Project	<b>IEEE 802.16 Broadband Wireless Access Working Group</b> < <a href="http://ieee802.org/16">http://ieee802.org/16</a> >	
Title	<b>Some Clarifications on CIDs and SFIDs and Suggested Modifications</b>	
Date Submitted	<b>2007-04-17</b>	
Source(s)	Dr.T.R.Padmanabhan School of Engineering Amrita University.	<a href="mailto:trpuma@yahoo.com">[mailto:trpuma@yahoo.com]</a>
	B.Yamuna School of Engineering Amrita University	<a href="mailto:b_yamuna@ettimadai.amrita.edu">[mailto:b_yamuna@ettimadai.amrita.edu]</a>
Re:	<b>General Contribution</b>	
Abstract	<b>Some Clarifications on CIDs and SFIDs and Suggested Modifications</b>	
Purpose	<b>Some changes involving CID and SFID as brought out here,may be incorporated in the standard</b>	
Notice	This document has been prepared to assist IEEE 802.16. It is offered as a basis for discussion and is not binding on the contributing individual(s) or organization(s). The material in this document is subject to change in form and content after further study. The contributor(s) reserve(s) the right to add, amend or withdraw material contained herein.

## Some Clarifications on CIDs and SFIDs and Suggested Modifications

Figure 7 -- Classification and CID mapping (BS to SS): T CID stands for transport CID

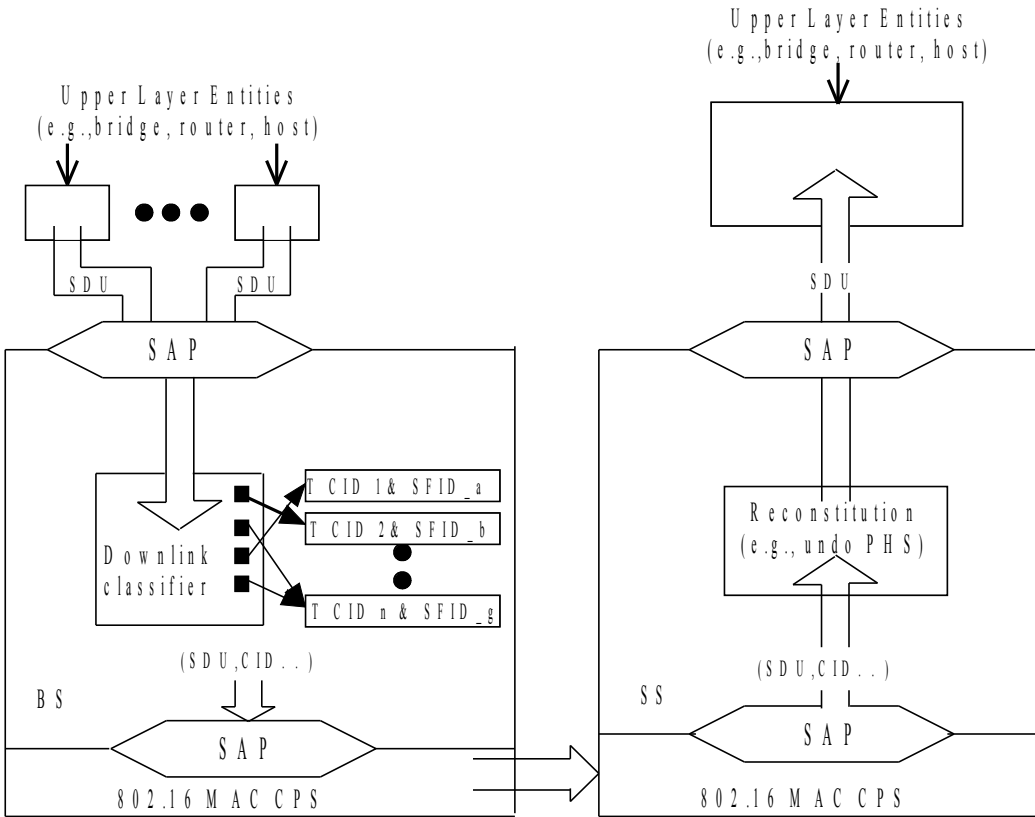
1) At the SS each service category has one or more CIDs identified with it. These are the Transport CIDs. Every Transport CID has an identified service category at the CPS of MAC. So at the SS Uplink classification involves mapping a transport CID to user PDUs. The SDU so formed has an SFID (with which the transport CID is identified). In contrast at the BS classification has two dimensions – one at SS level (concerning Transport CID) and the other at Service flow level (concerning SFID). For example, a BS may receive two SDUs from an SS – say SSa; one of these may have an SFID and a Transport CID. The other can have a different SFID with a different Transport CID.

Figure 7 and Figure 8 in the standard may be replaced by the respective figures below.

Figure 93 -- Provisioned authorization model "envelopes"

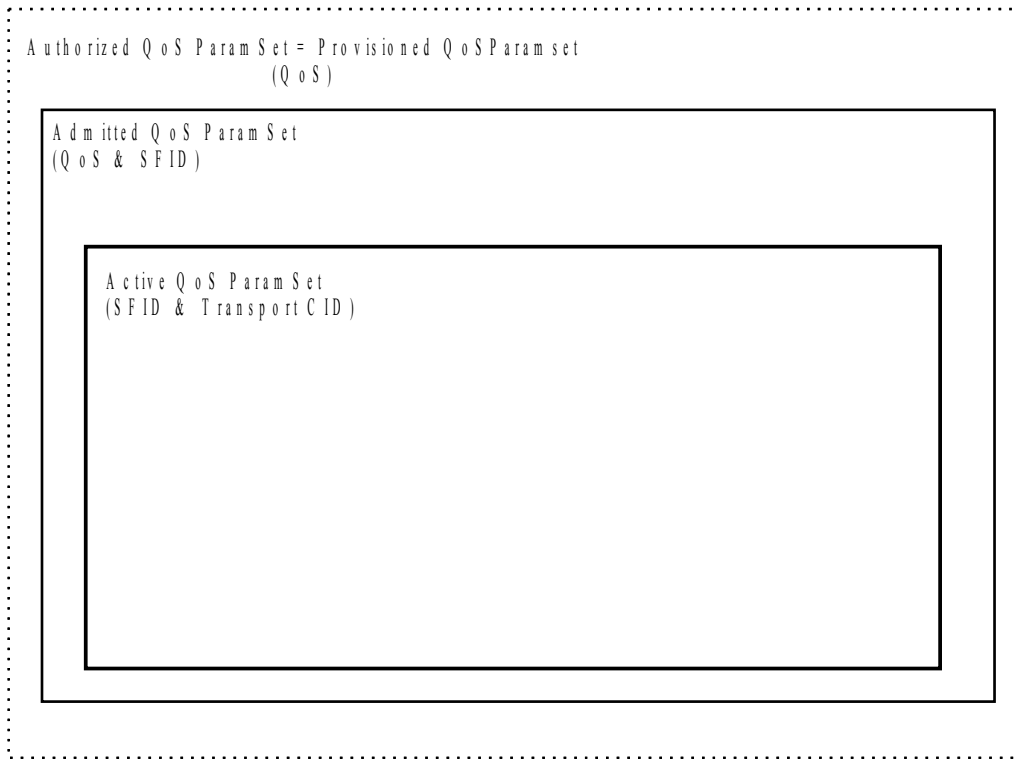
4) Figure 93 (page 220) raises an ambiguity regarding the provisioned QoS ParamSet. It is stated that “*This type of service flow is known via provisioning by network management system. SFID serves as the principal identifier for the service flow in the network*”. Going by this, SFID need not be associated with the QoS parameter Set; further provisioned QoS need not be treated as service flow.

Figure 93 in page 220 illustrates that admitted QoS ParamSet has SFID and CID. This raises an ambiguity because it is stated in page 225 “*the service flow type may change to admitted or to active; in the later case the service flow is mapped on to a certain connection*”. It implies that admitted service flows are not mapped to transport connections and hence no transport CIDs are associated with admitted service flow.

Figure 93 and Figure 94 may be replaced by the respective figures below.

**Figure 20 – Bandwidth request header format**

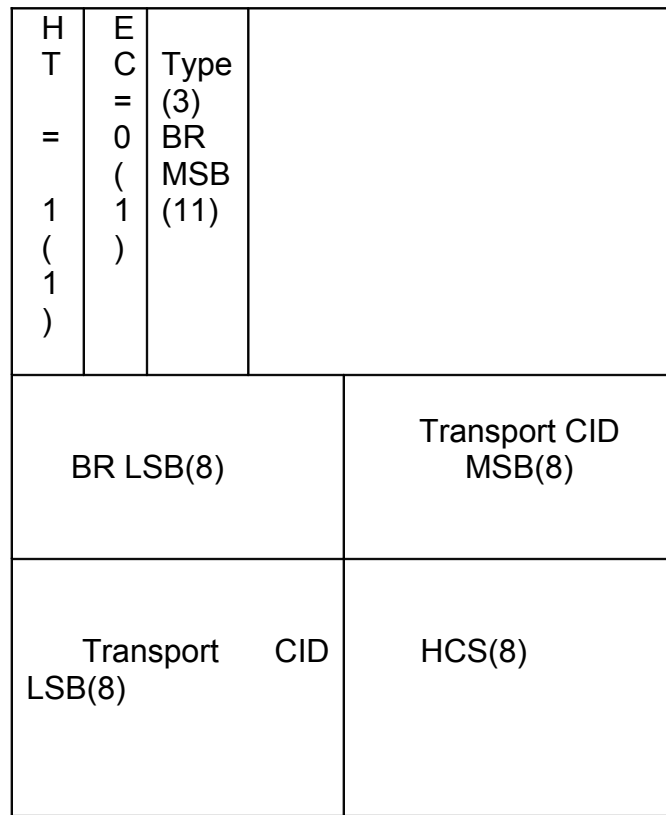
Figure 20 (Page 38) The Bandwidth Request Header Format may be replaced by the following

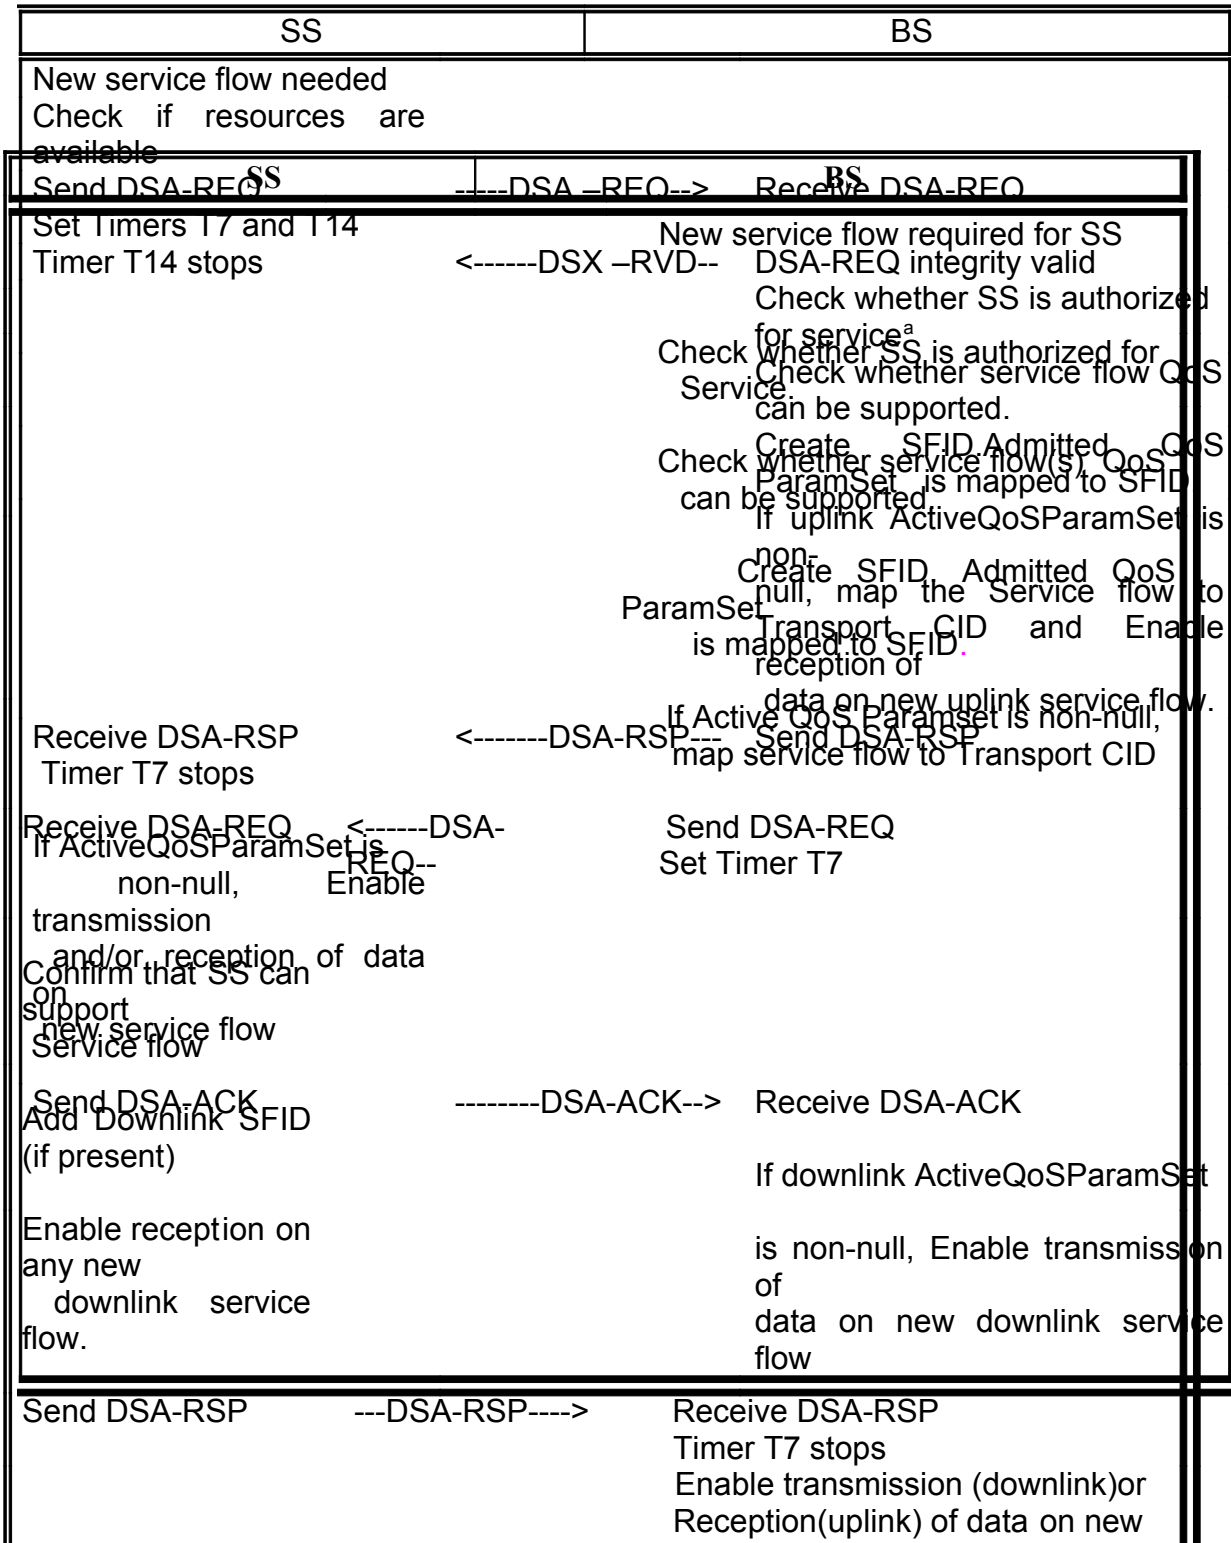
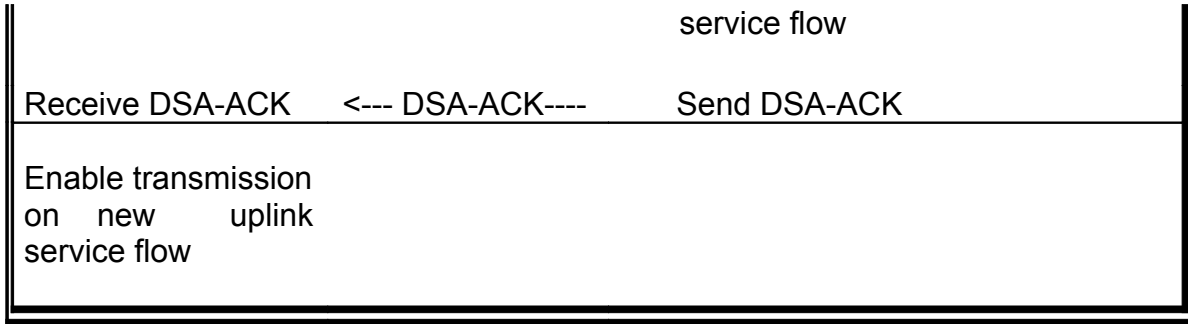
*“A DSA-REQ from a BS contains an SFID for either one uplink or one downlink service flow, possibly its associated CID, and a set of active or admitted QoS Parameters”*

to be changed to

“A DSA-REQ from a BS contains an SFID for either one uplink or one downlink service flow, admitted QoS parameters, and a set of active QoS Parameters( with its respective Transport CID)”.
